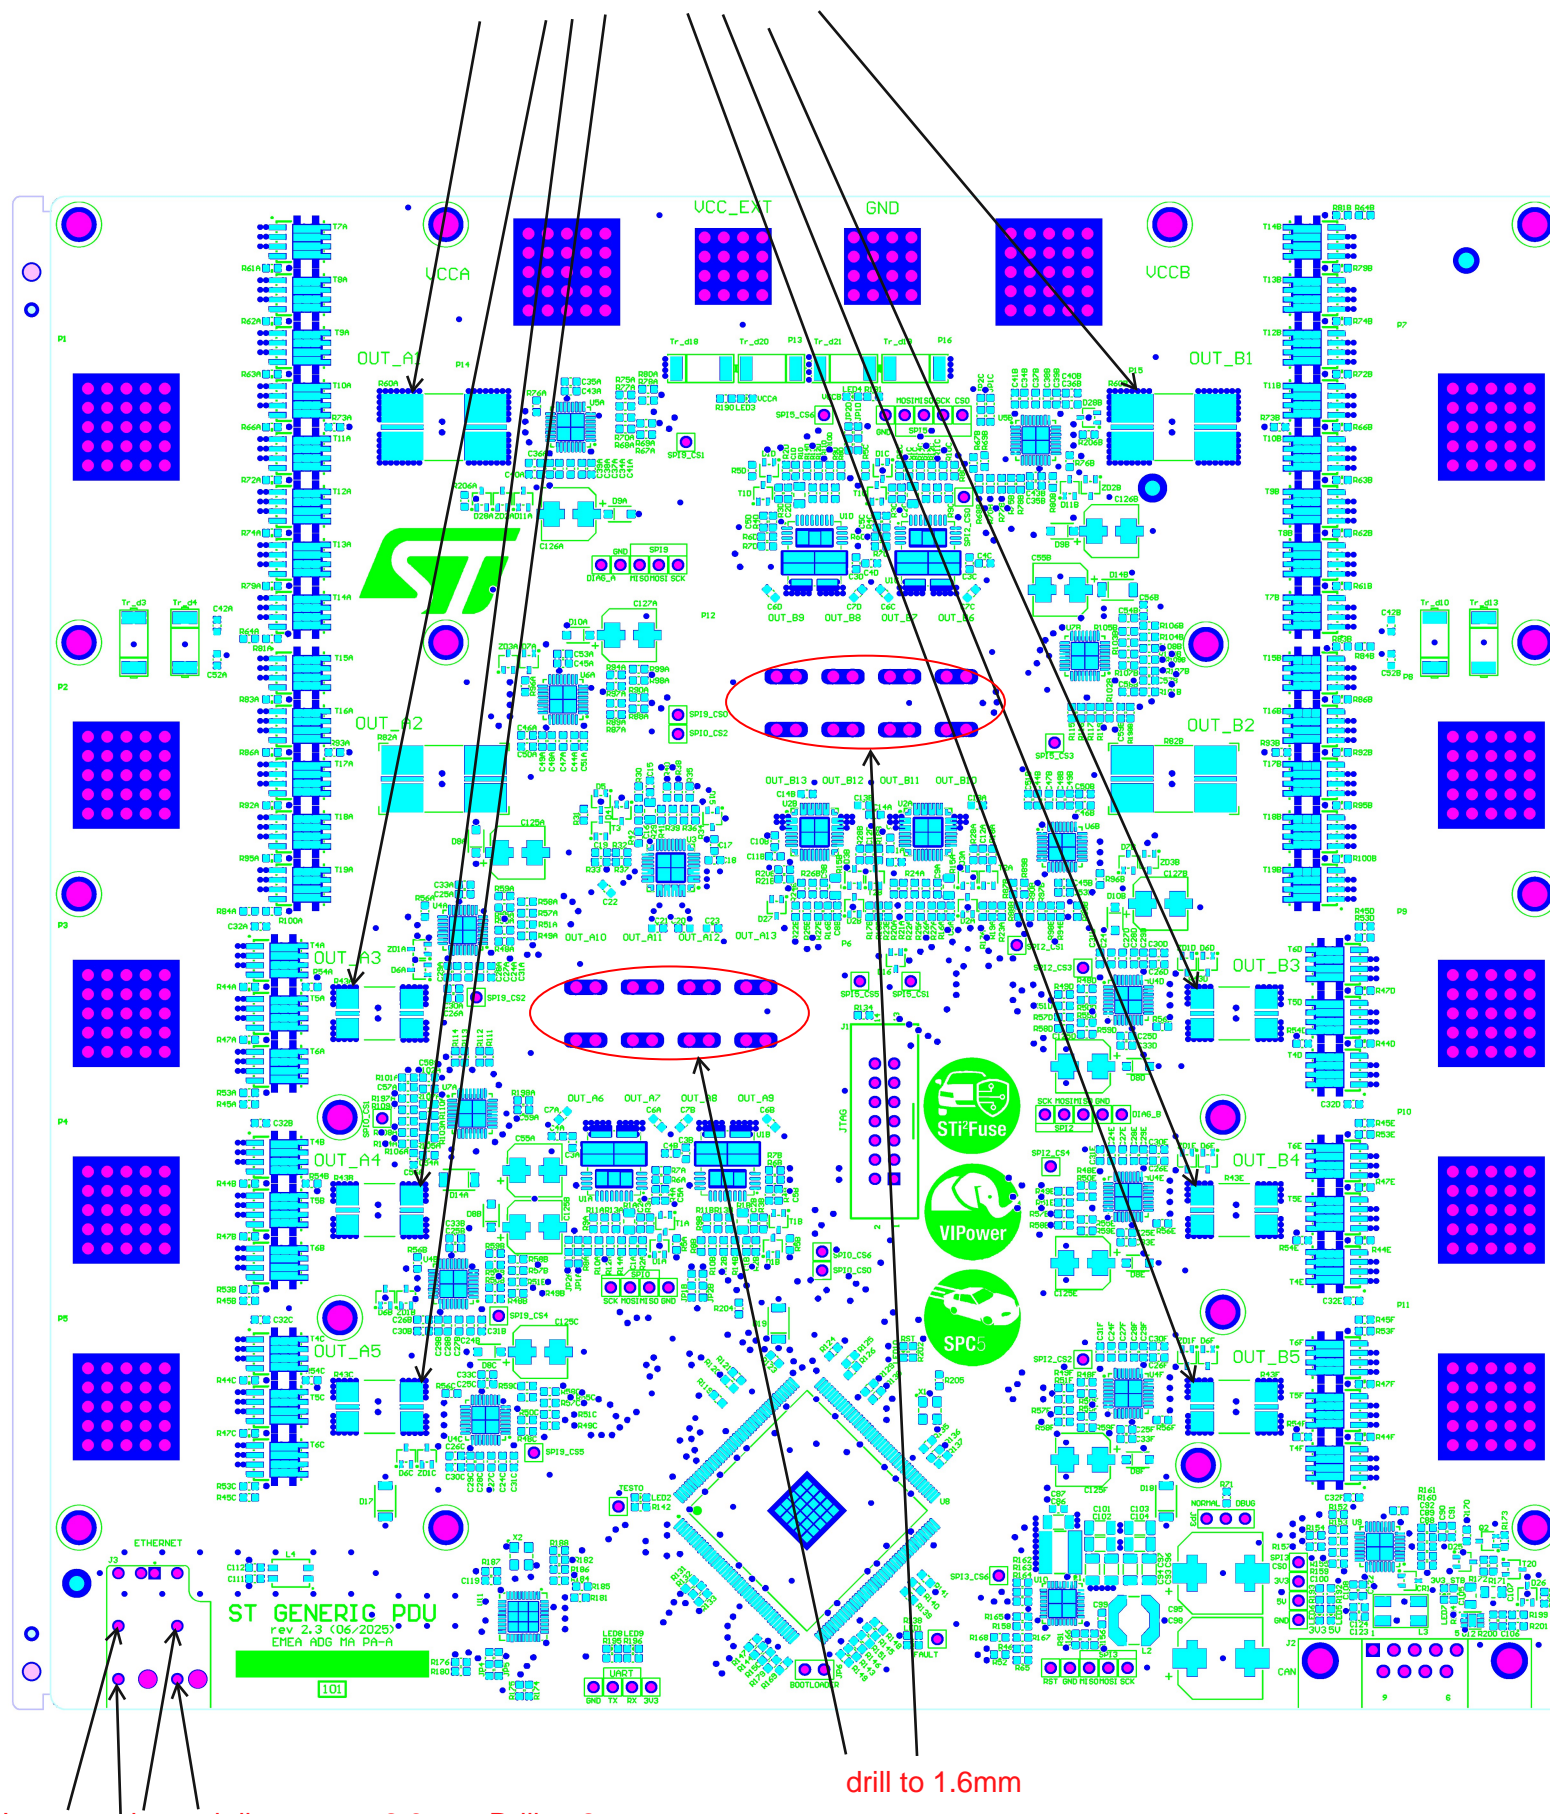
cover the side vias with solder

drill to 1.6mm

Increase the pad diameter to 2.6mm; Drill to 2mm
